**In the Drawings:**

### **REMARKS**

1. **Amendments To Drawings:**

Figure 11

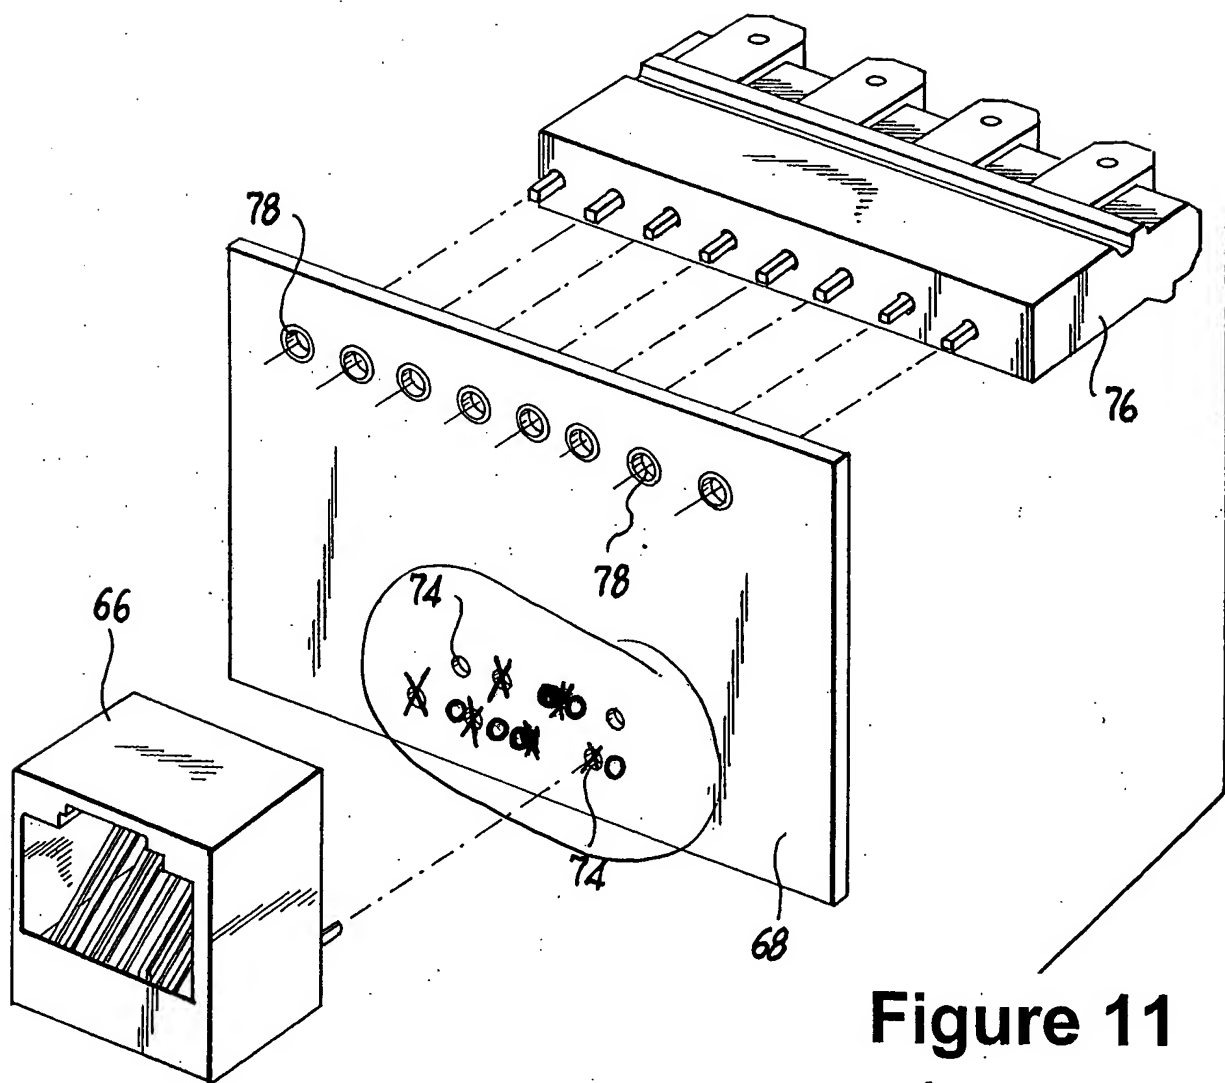
FIG. 11 has been amended to make the spacing between the upper row of PCB contacts 74 correspond to the spacing (shown in FIG. 3) between the upper row of extensions 46 of rear portions 40 . FIG. 11 has been further amended to make the spacing between the lower row of PCB contacts 74 correspond to the spacing (shown in FIG. 3) between the lower row of extensions of rear portions 54. This amendment is supported by the specification, for example, but not limited to, at page 18, lines 13-14, which states that “[m]odular housing 66 with insert 10 is electrically connected to a printed circuit board (‘PCB’) 68” and at page 18, lines 18-19, which states that the “signal transfers from inserts 10 via extensions 46 and 56 of rear portions 40 and 54 respectively, into PCB 68 via PCB contacts 74.
